MOTOR CONTROLS RH  LH   
 OPTIONAL SERVICE RH  LH   
 DOOR As Viewed From Inside Looking Out

SHOP DRAWING REVIEW!

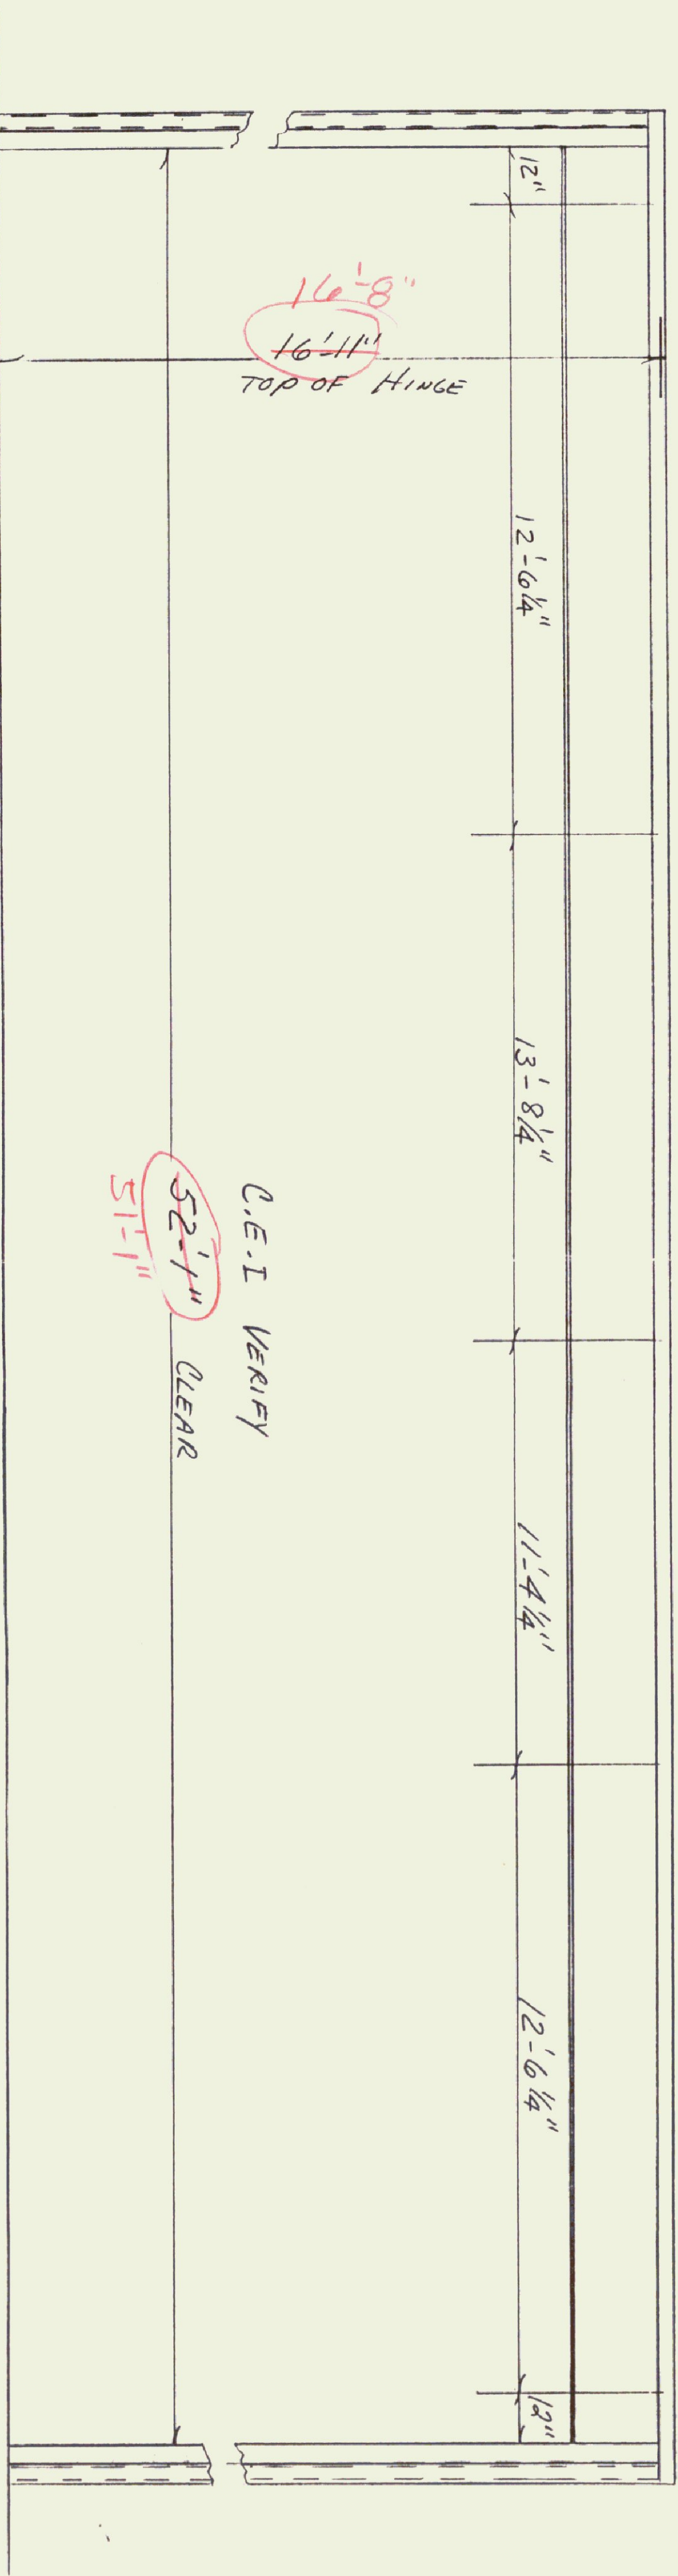
L 6X4X 3/8  
3/8" x 4" PLATE  
52'-1"  
51'-1"  
O.E.I. - FIELD VERIFY
